1 Products affected

Product hierarchy no. *			Part no.	SBU	Type / Description	Customer part no.
SBU PG	PGU	Type				
02	005	116	0000001168	See list below	Power Entry Modules w/o Filters	DD21

DD21					0118.2187	
creation date	created by	release date	released by	notification no.	revision	page
2013-10-04	hollenpe	2013-12-04	hollenpe	25286	-	1 of 2

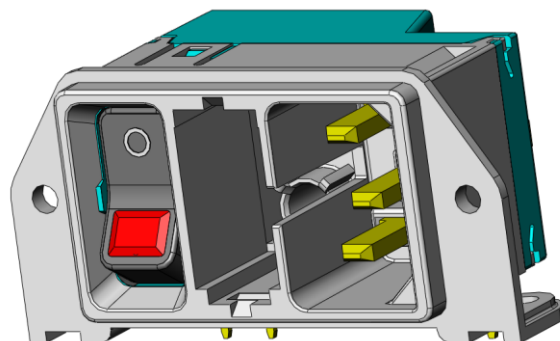
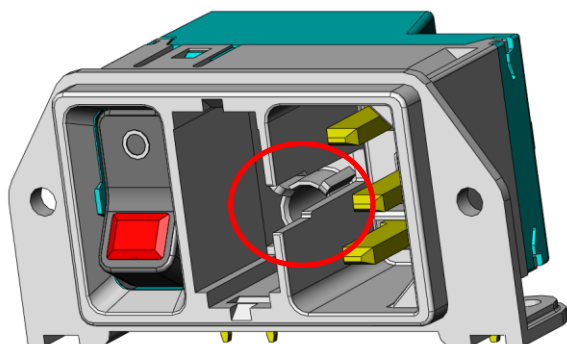
Enlarging of the fusedrawer slot.

Fusedrawer slot enlarged.

Implementation of V-Lock cord retention function.
Precondition: new fusedrawer required (see PCN 0118.2133).

Form: New form is fully backwards compatible (can be used with old fusedrawer, see PCN 0118.2133).
Fit: n/a
Function: The new expanded slot allows applying V-Lock cord sets for cord retaining (new fuse drawer necessary).
Production Site: n/a
Product Label: n/a
